## **DEVELOPMENT REVIEW COMMITTEE (DRC) COMMENT REPORT**

**Project Name:** MSC Enterprises / MSC Cluster Homes

**Case Number:** R15025

**Request:** Site Plan Level III Review: Five (5) Unit Cluster Development

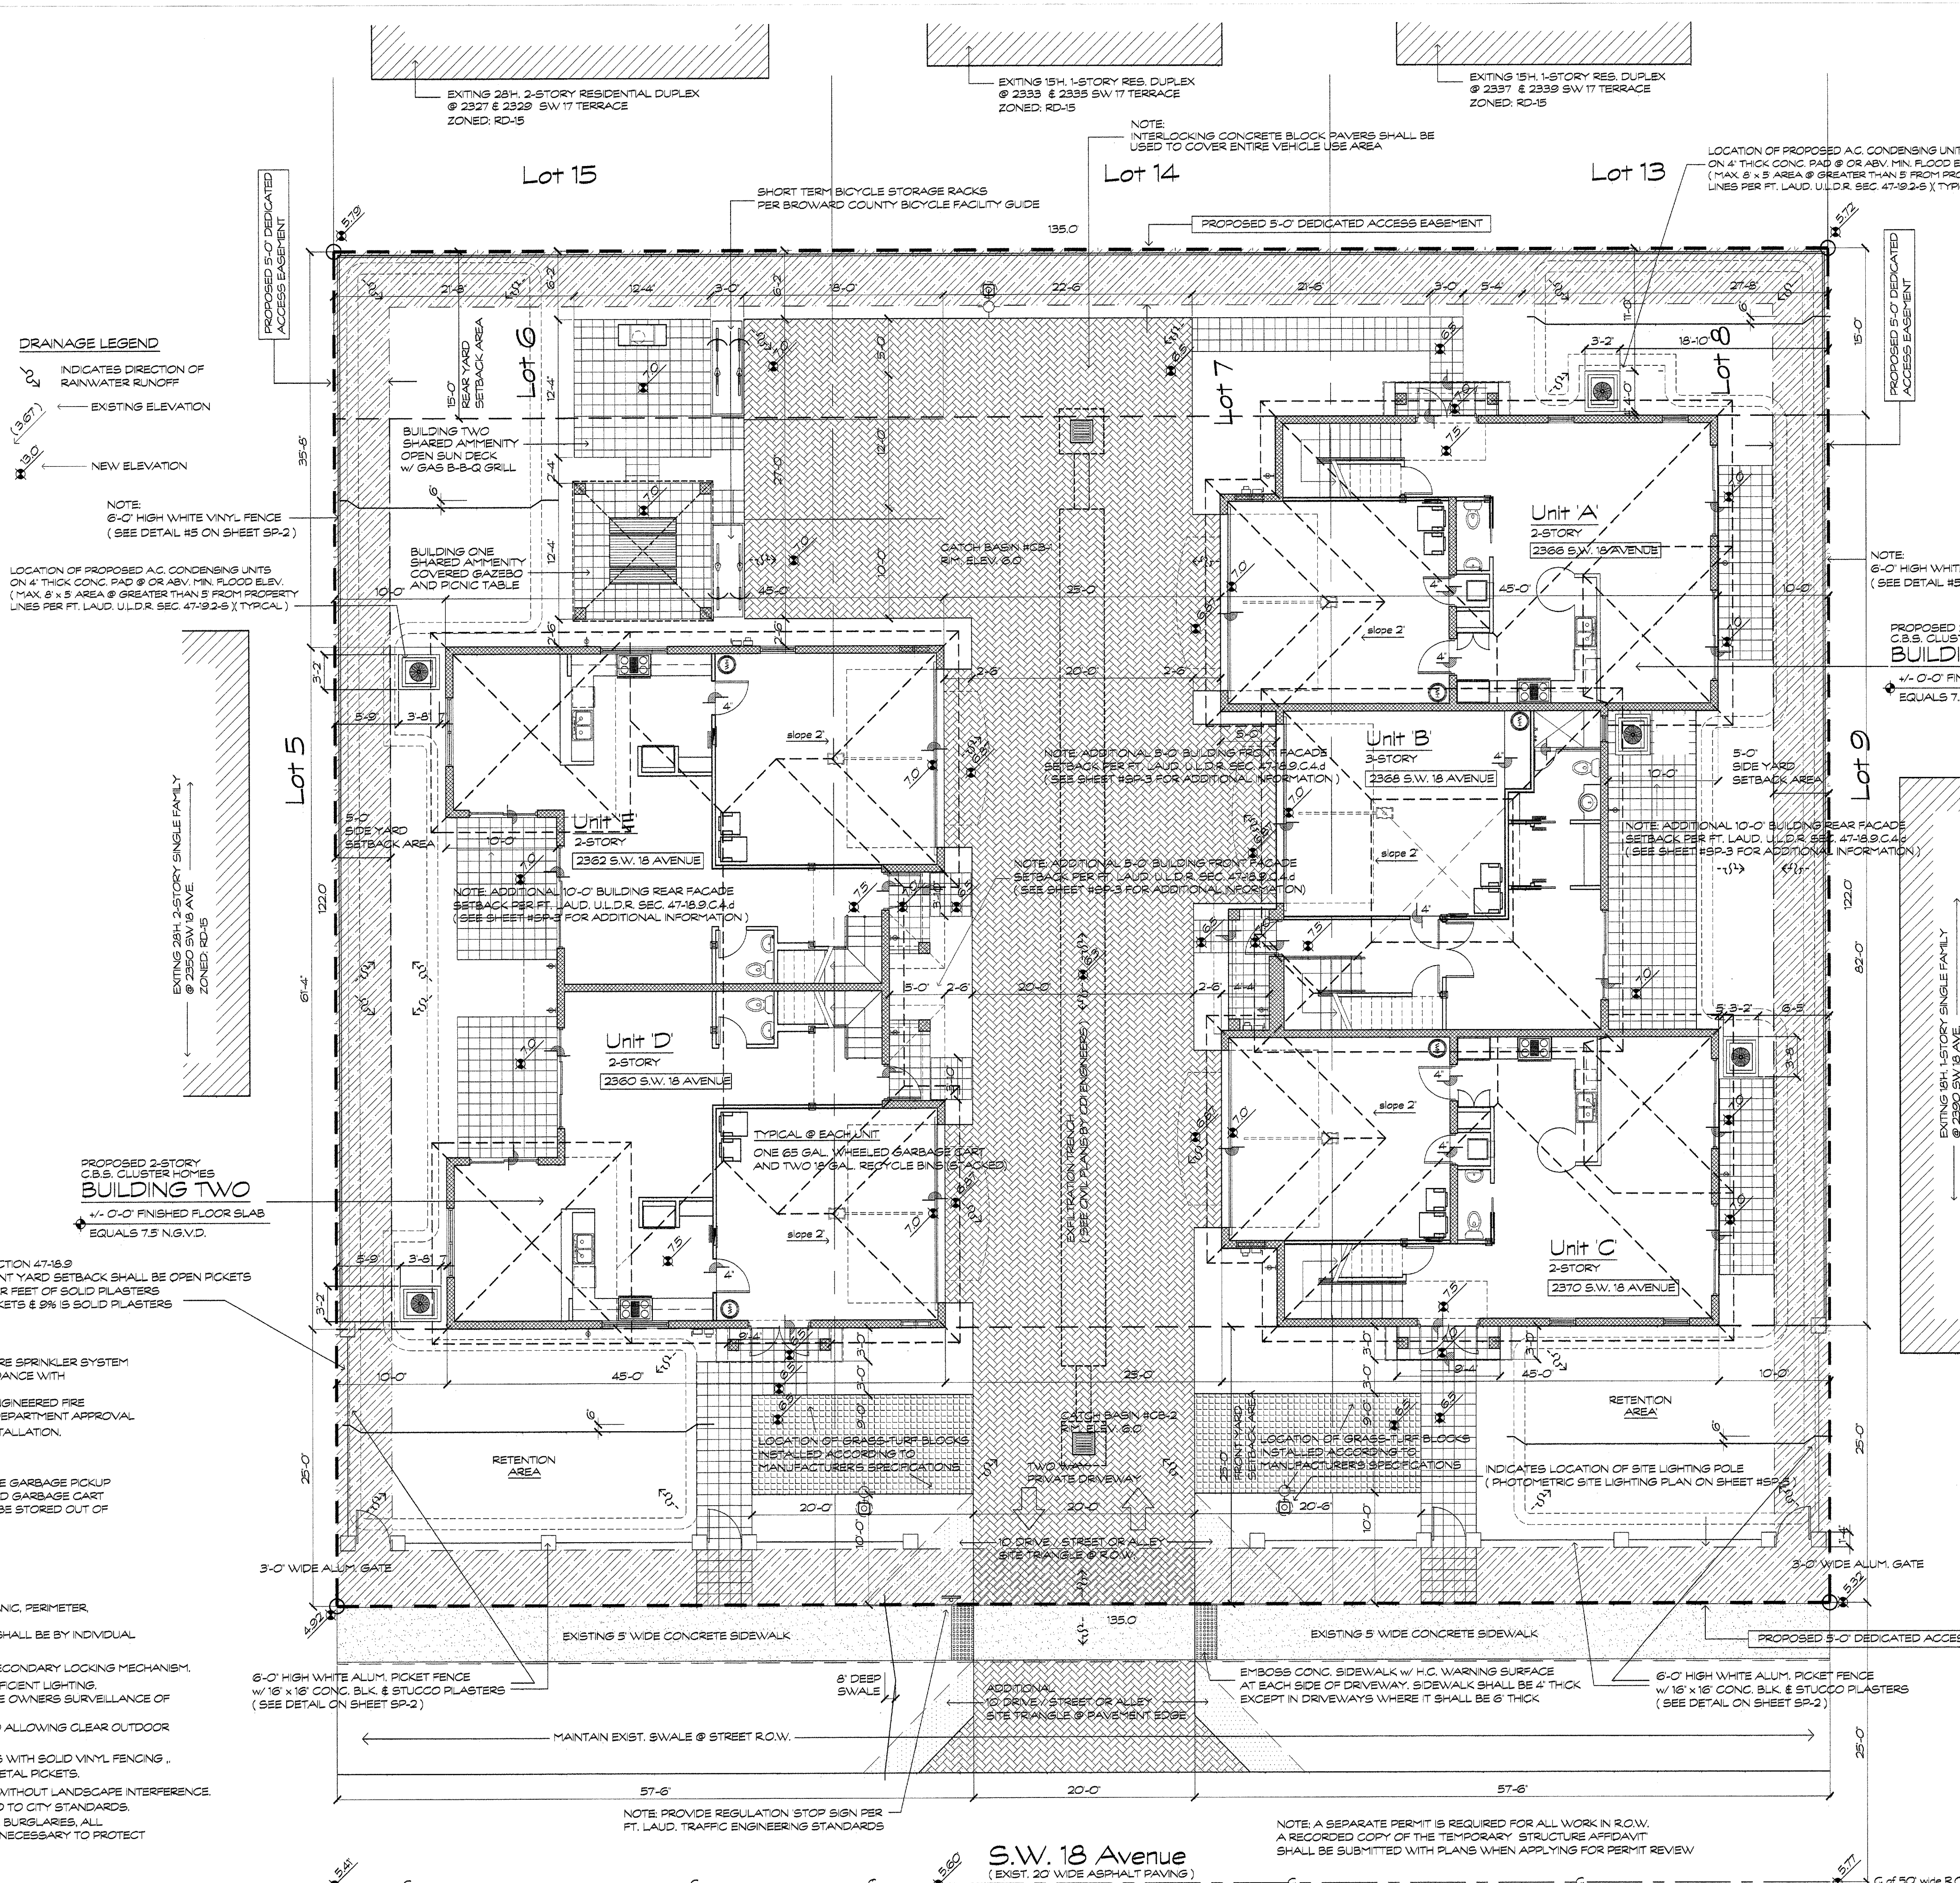
3. The existing trees on site stated to remain appear to be in conflict with proposed drainage and parking areas. Please confirm location and revise to avoid conflicts.

5. Place plant materials in hydrozones which correspond to irrigation volume.
6. The planters in the drive isles do not contain minimum soil volume for proposed trees, and appear to be in conflict with the roof overhang.

- 5) To address Cluster Development requirements:
  - a) Lower proposed fence from six-feet to four-feet to prevent a walled effect along the street and create more visibility and presence;
  - b) Provide an access easement over driveway area as required per Sec. 47-18.9.C.3;
  - c) Locate A/C units on individual rooftops and screen appropriately to address requirement of individual ownership. Provide elevation plans indicating A/C units are concealed from view pursuant to ULDR Sec. 47-19.2.Z.
- 6) Foot candle readings on the photometrics plan shall extend to all property lines.
- 7) The site plan shows an existing five-foot sidewalk. It appears that a sidewalk is not currently constructed adjacent to your site on SW 18 Avenue. Please provide and label accordingly.

7. Ensure **site plan** clearly indicates (labeled) locations of all solid waste and recycling containers and/or compactor(s) for all uses as proposed in application. Identify containers. Please indicate if the containers will be inside the garage and how many containers will be allowed per unit.

8. Provide on the site plan a garbage truck turning radii for City review. Drive aisle width and design configuration must allow for safe and efficient maneuverability on-site and off-site. Indicate how truck will circulate to/from/within property.

Front Elevation (North) / Building One

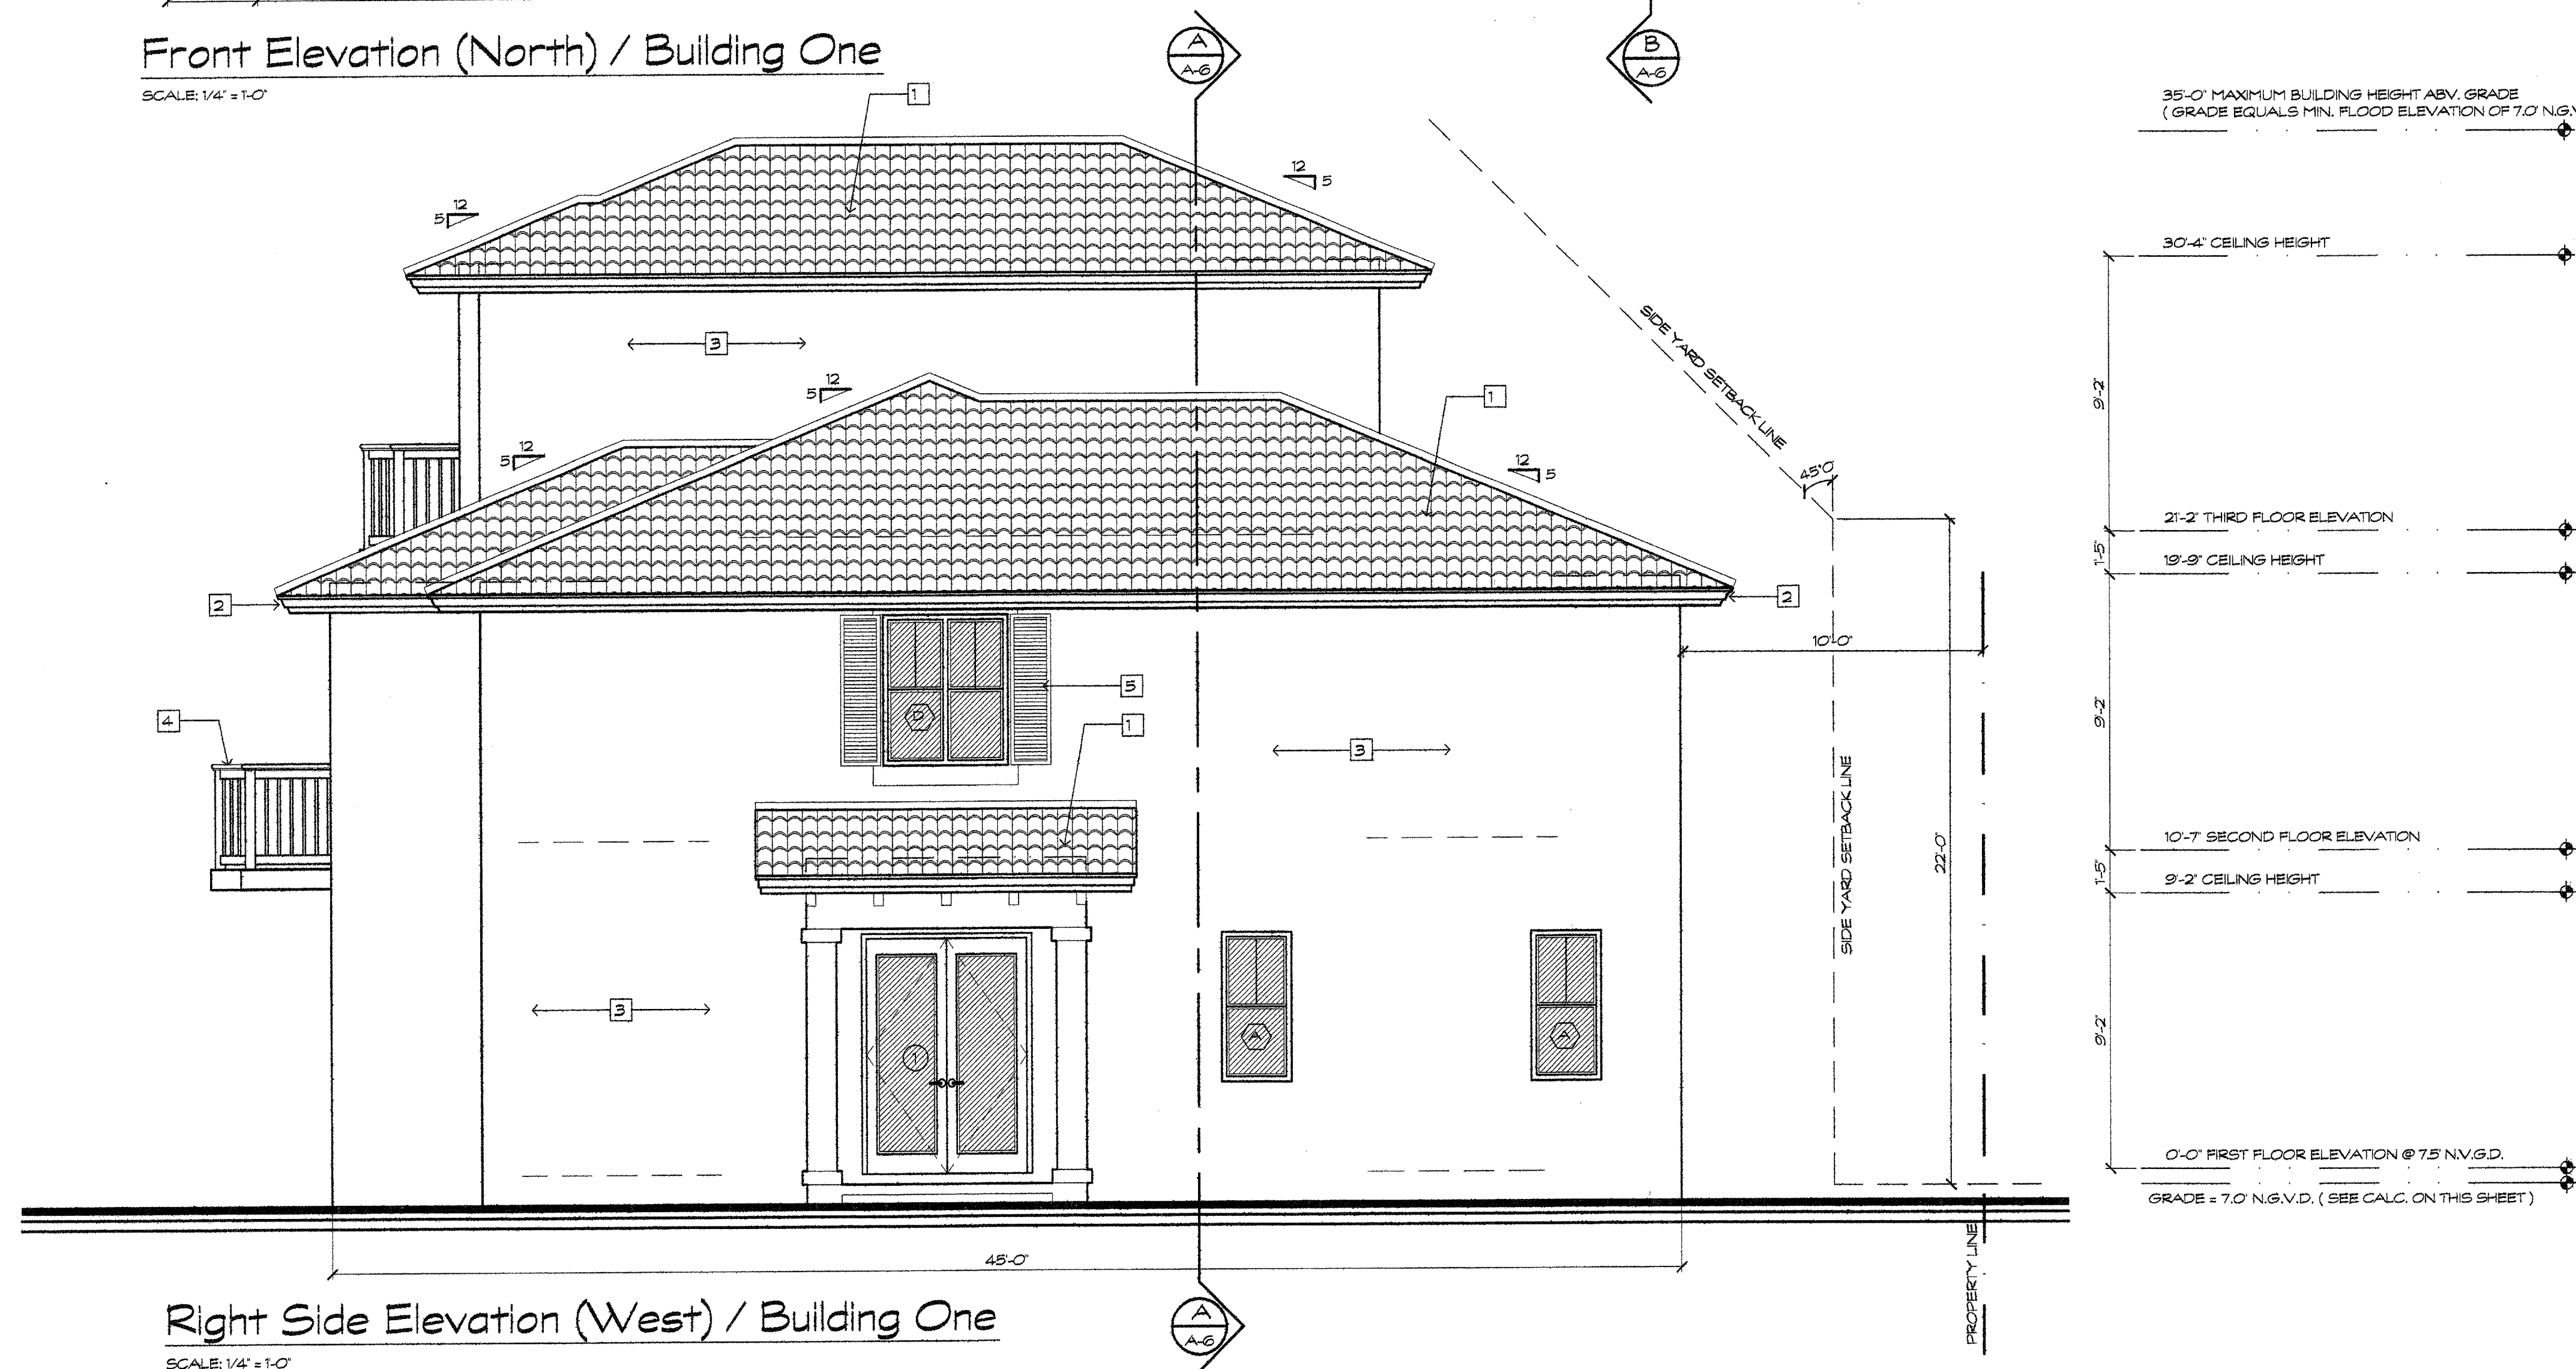
- 8) Please continue the proposed façade treatment that is currently shown on the north and south facades along the street and rear facing facades.
- 9) Incorporate on-street parking with bulb-outs for shade trees along SW 18 Avenue to improve the streetscape environment, while providing additional guest parking. Eliminate the two proposed surface parking spaces located in the front yard, where the area can be better utilized for landscape material, open space, visibility and access to units, and be more in context with the character of the residential area. Discuss bulb outs and shade tree placement in the swale with the Engineering and Landscape Representatives.
